# Coastal Access – Isle of Wight – Wootton Bridge to the Medina

## Representations on IOW 3: Culver Down to Binnel Bay and Natural England's comments

November 2021

Annex 5: MCA/IOW3/R/3/IOW0145

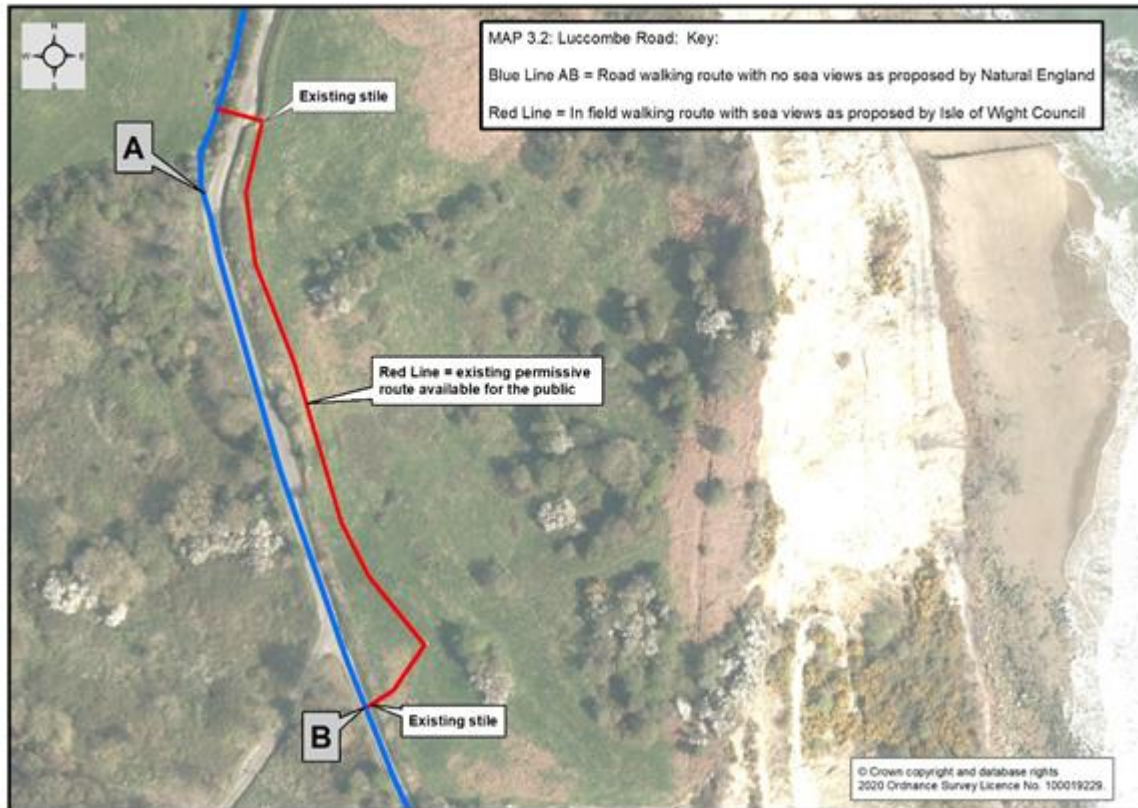
Route section IOW-3-S042 is along a road where walking in the actual carriageway is necessary due to there being no footway/pavement and no walkable verge.

- Any walking in a carriageway is unsafe and inconvenient no matter how low the risk.
- Walking along the road in this location does not guarantee views of the sea as this is wholly reliant upon the landowner keeping hedges cut to a low height, which of course they are under no obligation to do. At most times the hedges are high and this, coupled with a relatively narrow road, creates a tarmac corridor to walk along (see photograph 3.2 (1) attached).

- A field is available to the east of the road which is perfectly acceptable for use as the England Coast Path. It is difficult to understand why a route through this field has not been proposed by Natural England as the England Coast Path alignment. That land is already open to the public on a permissive basis, a path already exists with signposted entrance/exit points and stiles. This path complies with the provisions in section 4.7.1 of the Approved Scheme. It also provides unimpeded and fantastic views of Sandown Bay and Culver Cliff (see photograph 3.2 (4) attached. Such views will be completely missed if the proposed road route is adopted which would be a travesty and in breach of the main aims of the Coastal Access scheme i.e. the primary purpose of the scheme is to enable people to enjoy the coast of England by adhering to the periphery of the coast and to offer views of the sea from “**the trail**” – Approved Scheme 4.5.1 and 4.6.1.

The attached map 3.2 and photographs 3.2 (1) to (4) have previously been submitted to Natural England for consideration. The map outlines the Council’s proposed alternative route for this section through the field which is in compliance with the Approved Scheme for the following reasons:

The Council objects to the route of the trail as proposed by Natural England and requests that the Council’s suggested alternative route or another “off road” route is utilised as the England Coast Path trail.

After further discussions with the Council, and Island Roads completing an additional highways assessment (annex 6), Natural England has agreed a new route with the relevant landowner at this location (annex 7). This is as a result of discussions with the Isle of Wight Council and the Highways Authority subsequent to the publication of the report, which made it clear that the modified route option would be easier to maintain in the future and is also safer, closer to the coast and provides better views of the sea (annex 8). We originally proposed the published route as the modified route does double-back on itself and the local

We ask the Secretary of State to approve the amended route as set out on the map included in annex 9. Accompanying this map, we have also included a revised entry for table 3.3.1.

### 5.1 Lucombe Road

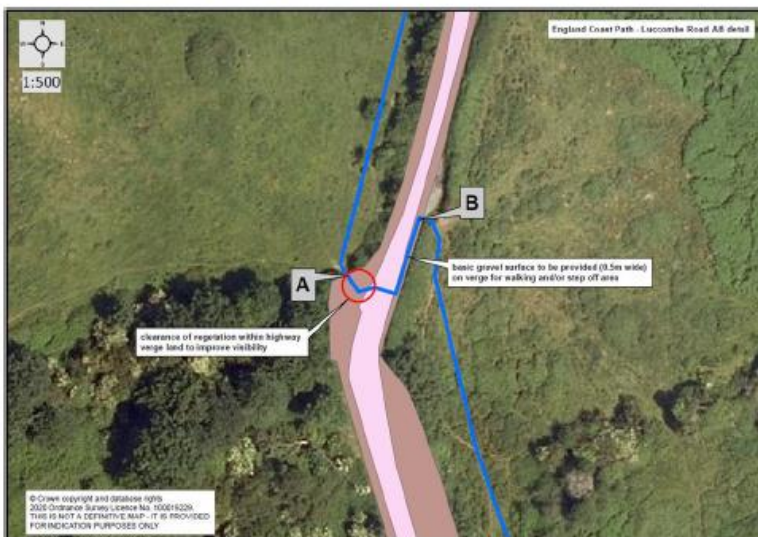
The proposal would result in a narrow strip of roadside verge being upgraded to provide a firm and level surface for pedestrians.

Pedestrians would be required to cross at point A on the plan below and then walk along the upgraded verge to point B. The proposed crossing point is near a street light which will help pedestrians to use the crossing safely at night.

Image 58 – proposed location of 0.5m roadside strip for pedestrian step off

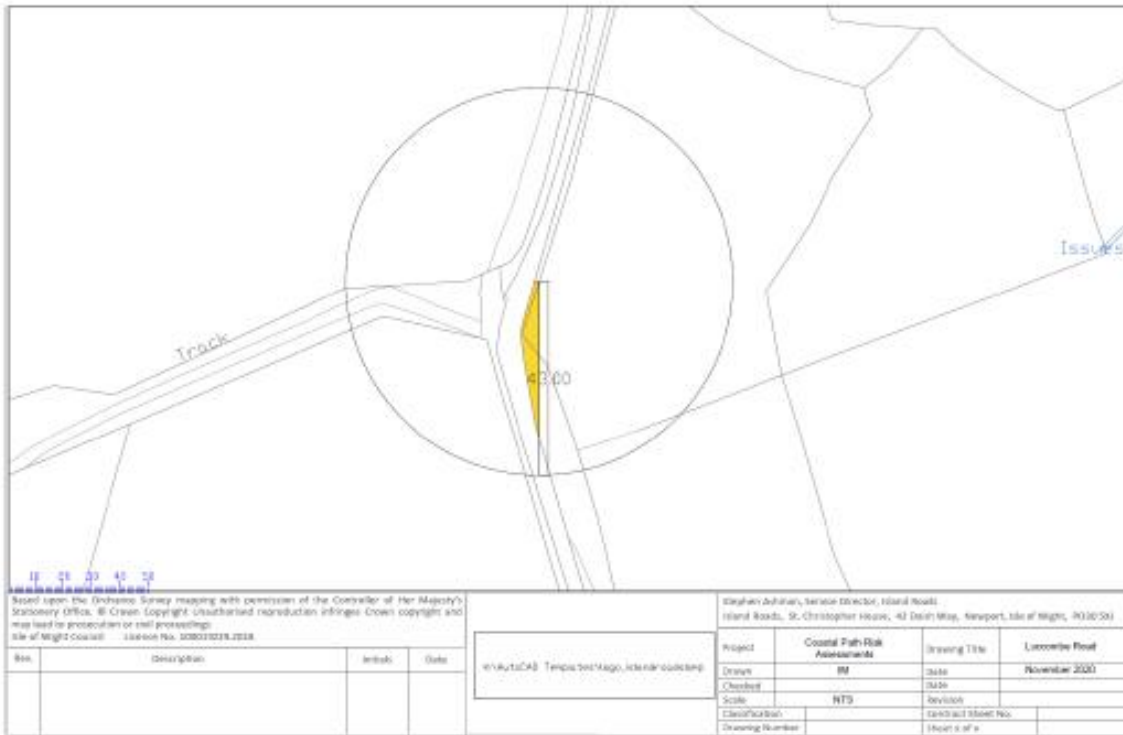
The bank on the eastern side of the carriageway slopes away quite steeply so some form of retaining feature will probably be required to provide the 0.5m strip proposed. There is also a risk that the introduction of a gravel path may encourage verge overrun as the carriageway width and 0.5m gravel surface may allow some vehicle to pass on this section. The strip would need to be capable of withstanding occasional overrun so that frequent maintenance is not required.

It is also recommended that the vegetation is cleared in the area highlighted yellow below to ensure that there is suitable visibility at the crossing point.

Map 2: Natural England's published England Coast Path route (2020) (indicative)

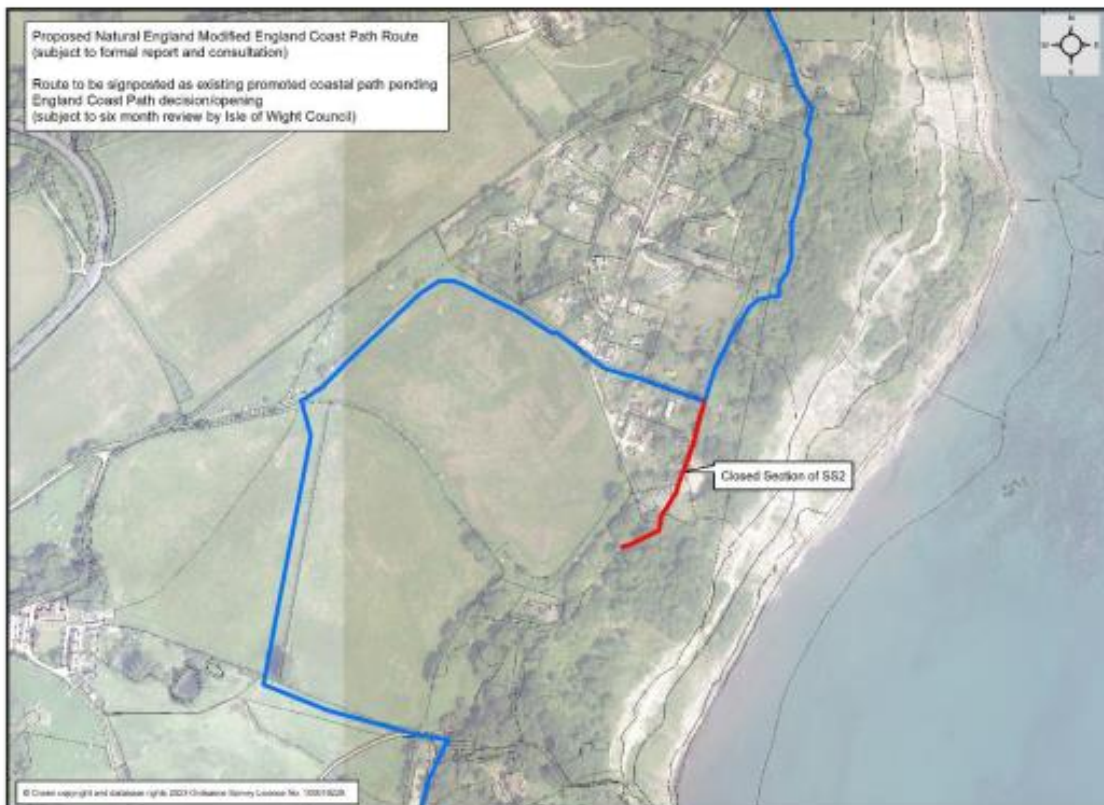
The proposed route for the realignment of the England Coast Path at Luccombe for the modification report will include the use of Bracken Dell (east) as a connection between Public Footpaths SS2 and SS88 (see Map 3 below), as Natural England contend that this has met the required appropriate balance required in their Coastal Access Scheme.
